20 JULY 2000 ADDITIONS TO THE SAP FOR AREA 30.

BASEWIDE RI/FS LAKE ONTARIO ORDNANCE WORKS	COMPONENT 2 (SOMERSET GROUP) PROCESS AREA 30 & 30A, PHASE II SAMPLING LOCATIONS	DESIGNED BY SMS	DRAWN BY FDV	DATE AUGUST 2000	PROJECT NO. 60957.46
		CHECKED BY SMS	PROJECT LEAD HGP	SCALE AS SHOWN	DRAWING NO. B-11-1

20 JULY 2000 ADDITIONS TO THE SAP FOR THE BACKGROUND SAMPLING

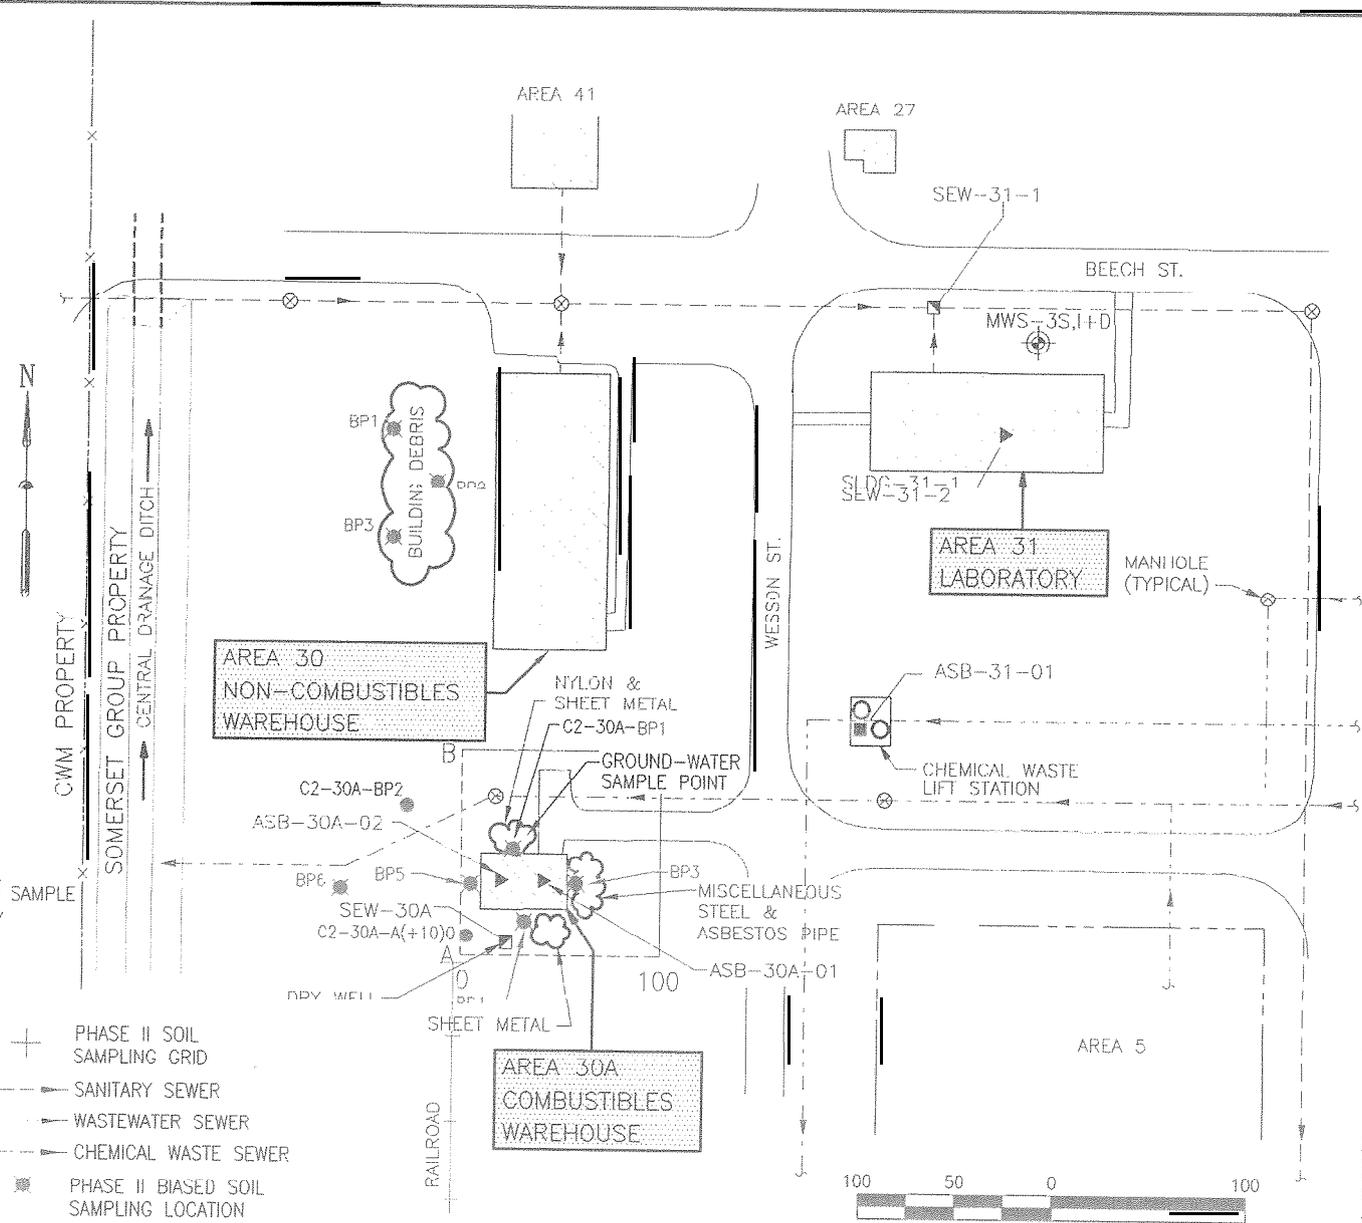
Because Area 30 was not included in the original Phase II investigation, a SAP does not currently exist. Area 30 was not included in the original scope of the Phase II RI due to previous use of Building 30-1 for storage by the current land owner. However, a debris pile west of the building appears to be a relict from decommissioning of AFP-68. An investigation of the debris pile was approved by the USACE in the letter dated 20 July 2000. The investigation shall include the following:

A reconnaissance of the debris pile will be performed to evaluate whether there appears to be debris not associated with the decommissioning of the AFP-68. This evaluation will be qualitative and will be made by assessing the relative age of the material based on weathering, potential dated material, potentially recovered model numbers of debris pile constituents. A photograph log will also be completed for the debris pile. If the age evaluation indicates that the debris is not recently deposited, but may have been deposited during decommissioning of the plant, three sampling locations will be established (see revised Figure B-1 1-1).

A direct push rig will be used to collect a surface soil sample (0 to 0.5 ft bgs), a semi-subsurface soil sample (4 to 5 ft bgs), and a subsurface soil sample (near the upper tills, Glaciolacustrine Clay contact). The sample intervals may be changed at the discretion of the field geologist based on possible observations of elevated organic vapor concentrations or soil staining.
